0.0 Planning Application PLN18/0615 at 124 to 128 Manningham Road, Bulleen for the use and development of a four-storey building comprising childcare and medical centre uses, plus 16 dwellings and associated basement and sub-basement car parking, and altered access to a road in a Road Zone, Category 1

File Number:	IN19/388
Responsible Director:	Director City Planning and Community
Applicant:	ANH Development Pty. Ltd. C/- Apex Town Planning
Planning Controls:	Residential Growth Zone Schedule 2 and Design and Development Overlay, Schedule 8-1
Ward:	Koonung
Attachments:	1 Decision Plans 2 Legislative Requirements

Clause 55.04-1 Side and rear setbacks

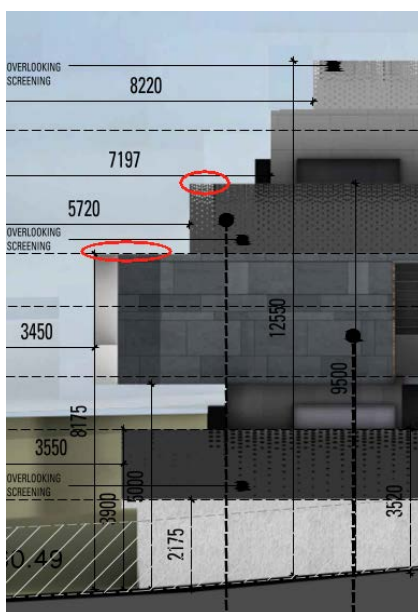
7.33 The setbacks numerically required by Standard B17 of Clause 55.04-1 have been met in all instances, with exception of two minor wall/balcony elements upon the western elevation, circled in red in the image below.

7.34 These elements are located at the southern end of the eastern elevation, where slope is greatest. The eastern boundary setbacks proposed fall approximately 25cm short of the setback suggested by Standard B17. These shortfalls are located opposite a narrow service yard of No. 130 Manningham Road. The adjoining dwelling has no windows facing this particular section of the building. Neighbouring residents utilising the service yard would not see beyond the boundary fence, and therefore these small encroachments are unlikely to be perceivable.

- 1.1. Greater detailing of the room layout (including permanent cots/beds, bag locker areas, storage areas, change areas, door swings etc.) with an accurate calculation of the unencumbered floor space provided per room;
- 1.2. The location of any glazed elements required to facilitate supervision within the rooms and rooftop play area;
- 1.3. The western boundary setback of the third level bathrooms/stairwell servicing the rooftop play area to demonstrate compliance with Clause 55.04-1 (Side and rear setbacks) of the Manningham Planning Scheme;
